Manual 15, Cost Development Guidelines

Cost Development Subcommittee
April 6, 2026

Revision 49 (10/01/2026):

**Manual 15, Rev 49 – Regulation
Redesign Phase 2**

Cost Increase due to Heat Rate increase during non-steady state

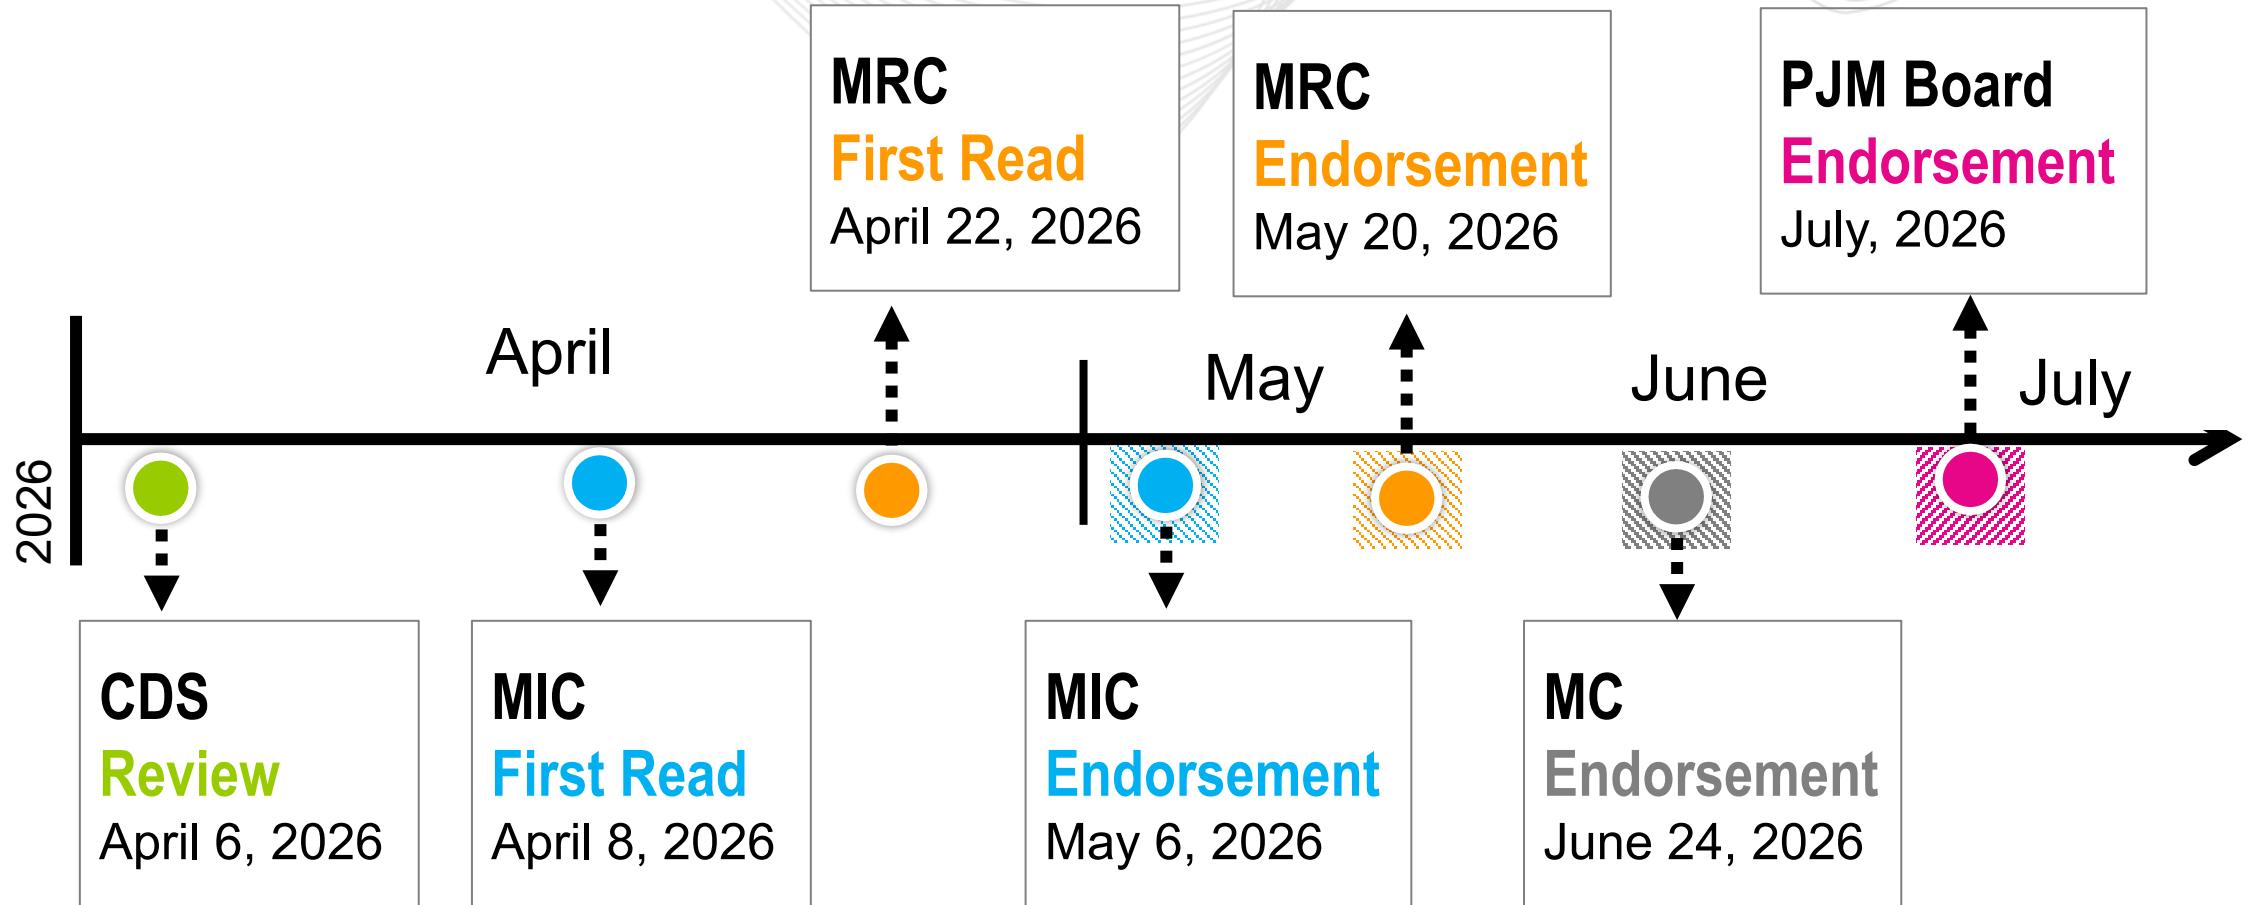
- Updated heat rate loss factor from .35% to .175%

The cost (in \$/MWh of Regulation) increase due to the heat rate increase resulting from operating the unit at a non-steady-state condition. This heat rate loss factor rate shall not exceed 0.17535% of the top Regulation load MW heat rate value.

Heat Rate Adjustment (Non-Steady State Operation)	Value	Units
Total Operating Point Heat Rate	9,000.0	Btu/kWh
Heat Rate Loss Factor (Max per M15)	0.17535%	
Heat Rate Loss	3.15	MMBtu/Hr
